# ENGAGEMENT REPORT

Draft Design Standard for Residential Driveway  
Crossovers and Associated Code Amendment

By the State Planning Commission

**TD-D Sightlines**

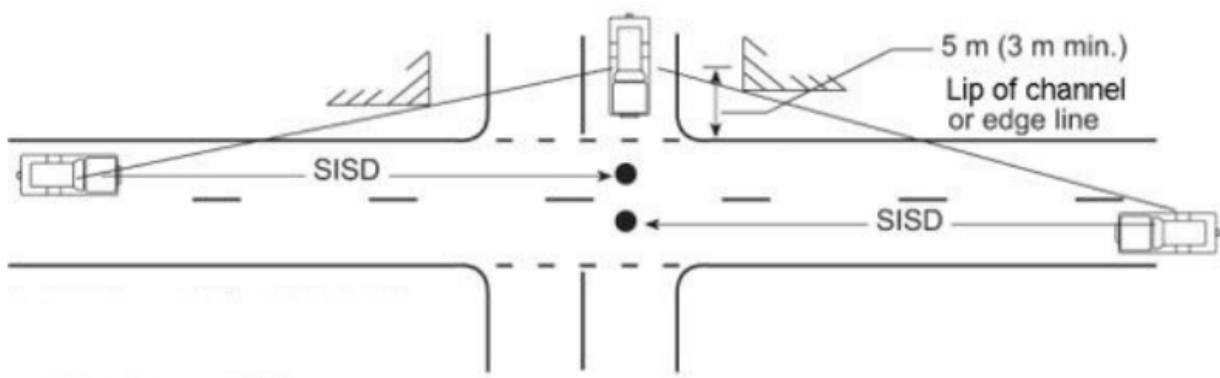
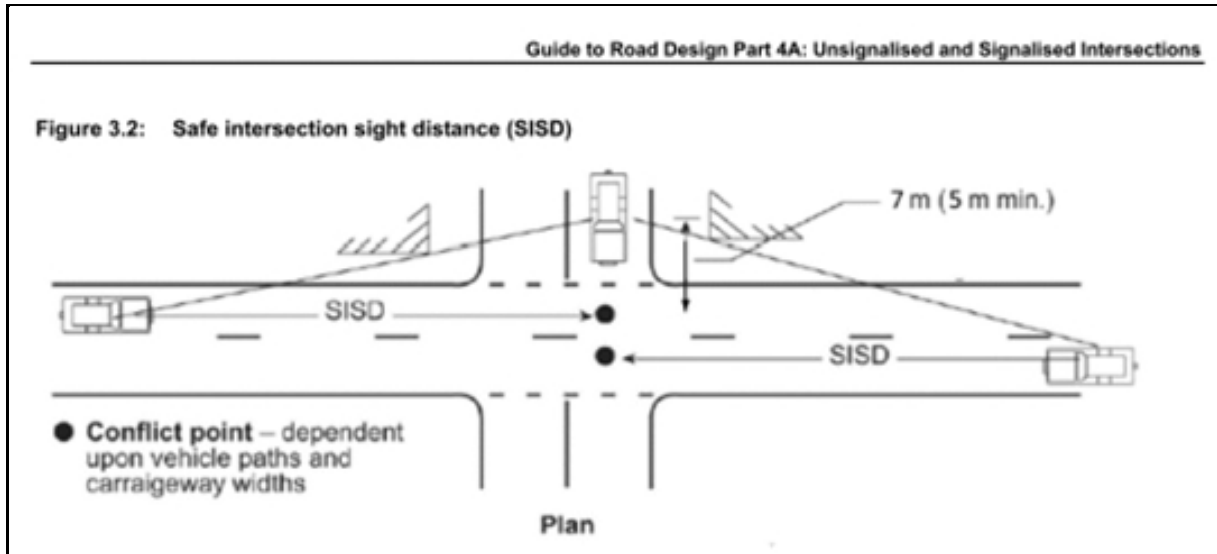
- The **TD-D diagram** above for the draft Design Standard was originally adopted from the Austroads *Guide to Road Design Part 4A* guidelines. This sight line figure has recently been updated in the Austroads *Guide to Road Design Part 4A 2023*, with a subtle change to the positioning of the exit vehicle for the assessment. Previously the setback distance was measured from the alignment of the kerb. The setback distance in the 2023 revised guidelines is now measured from the centre of the left-hand side lane (see below).
- The **TD-D diagram** should be updated to reflect the figure in the Austroads *Guide to Road Design Part 4A 2023* to achieve consistency.

**TD-F Driveway crossover grades- allotment lower than the road**

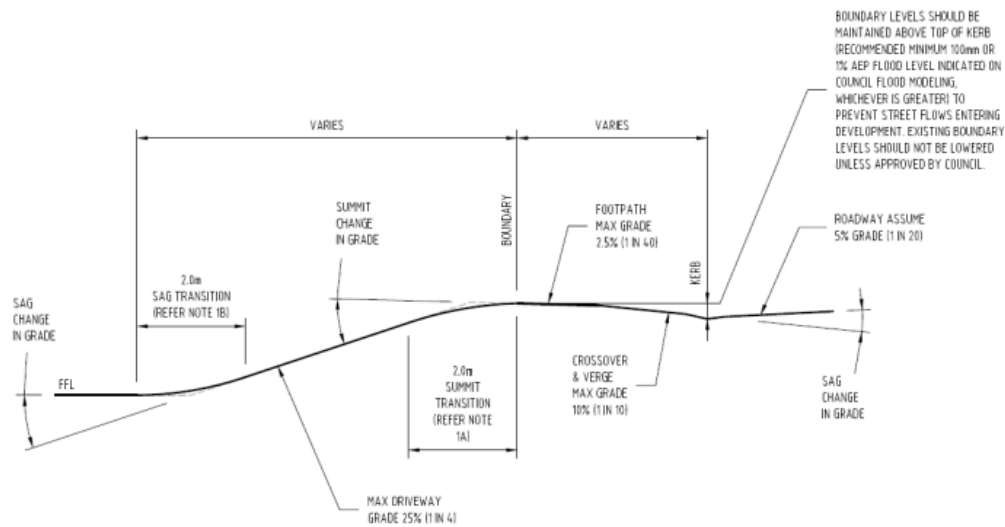
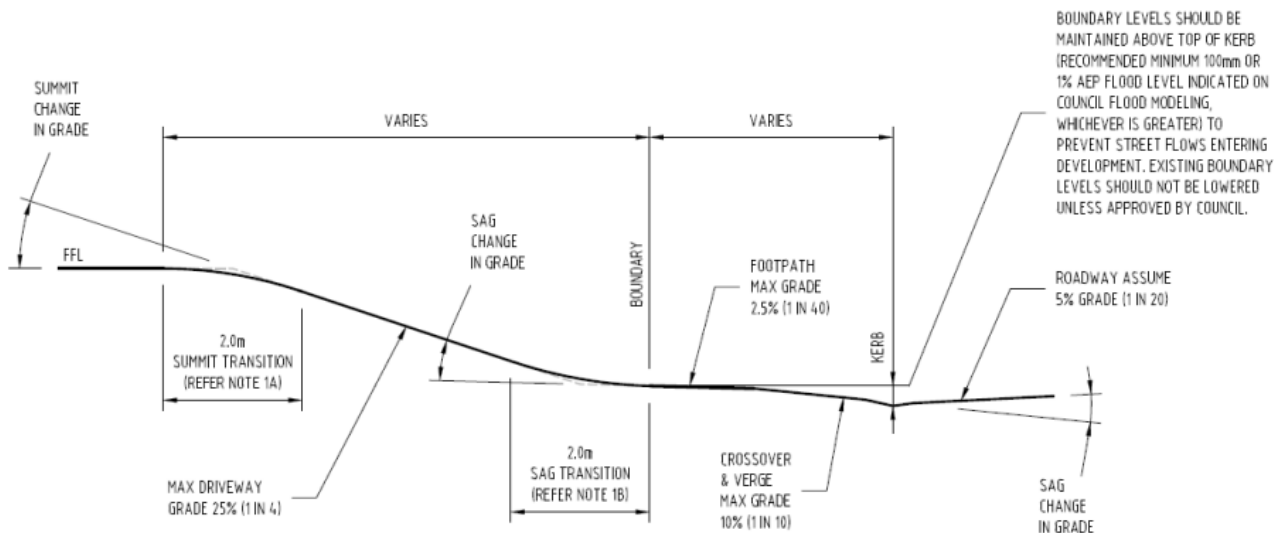
- Reference to TD3, when it has been put forward as TD-F Driveway crossover grades- allotment lower than the road.
- Incorrect assignment to note for 2.0m SAG transition.
- Incorrect assignment to note for 2.0m Summit transition.

TD-H Footpath transitions and crossfalls

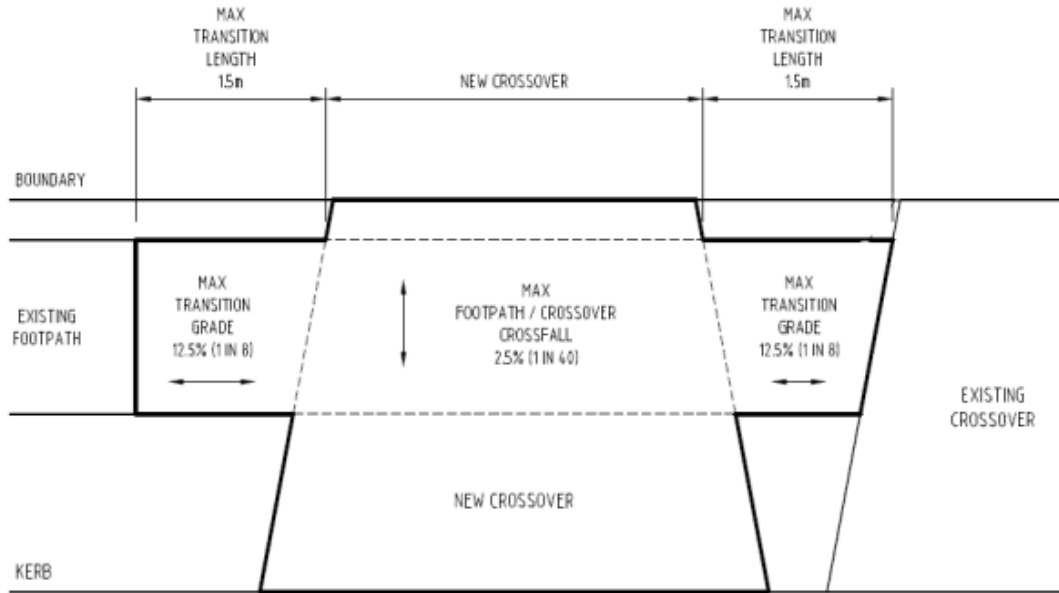
- Two-way arrow shown for max footpath/crossover crossfall. This should be a one way (down) arrow.
- Recommend that reference to AS 1428- Design for Access and Mobility is included.

- Pedestrian Sightlines

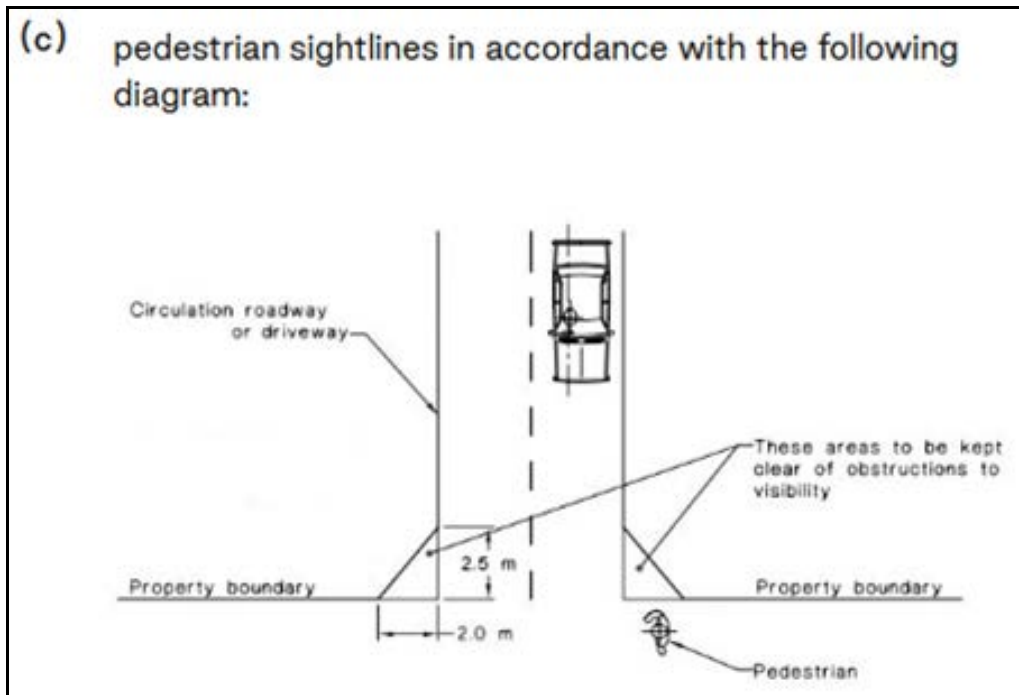
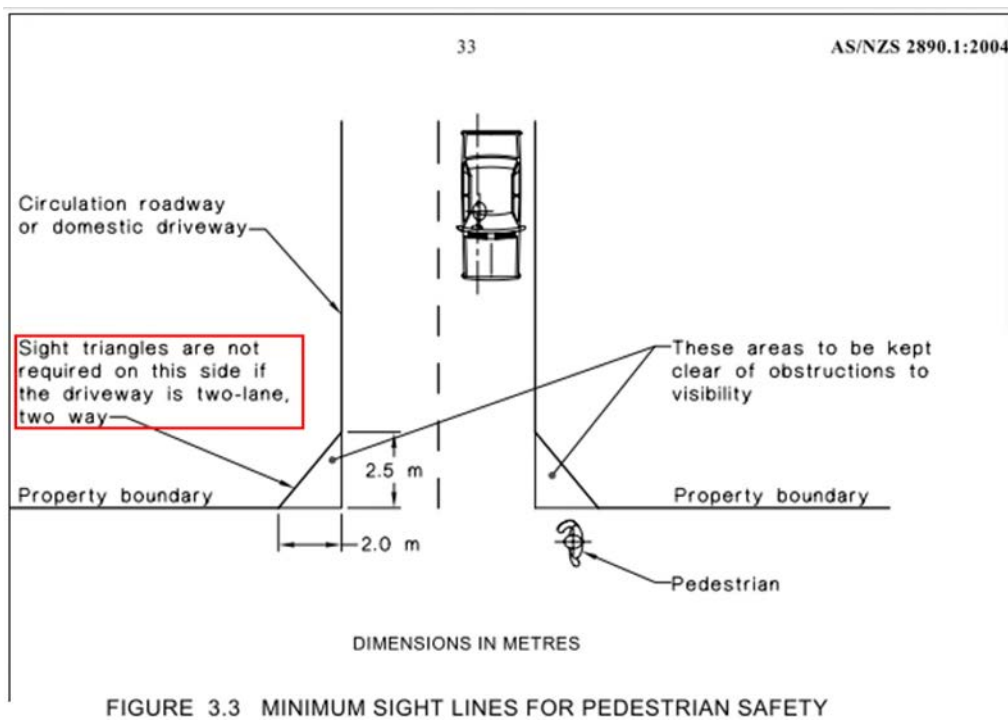
As a separate comment, the above figure in the Planning and Design Code for the pedestrian sight line is a derivation from Figure 3.3 of AS/NZS 2890.1:2004 (see below). I believe that the Planning and Design Code diagram is incorrect. The Figure from AS/NZS 2890.1:2004 states that if it is a two-way driveway, the pedestrian sight triangle on the right-hand side of the exit driver is not required, because the entry lane already provides the 'clearance distance' to view the approaching pedestrian, which is a logical observation.
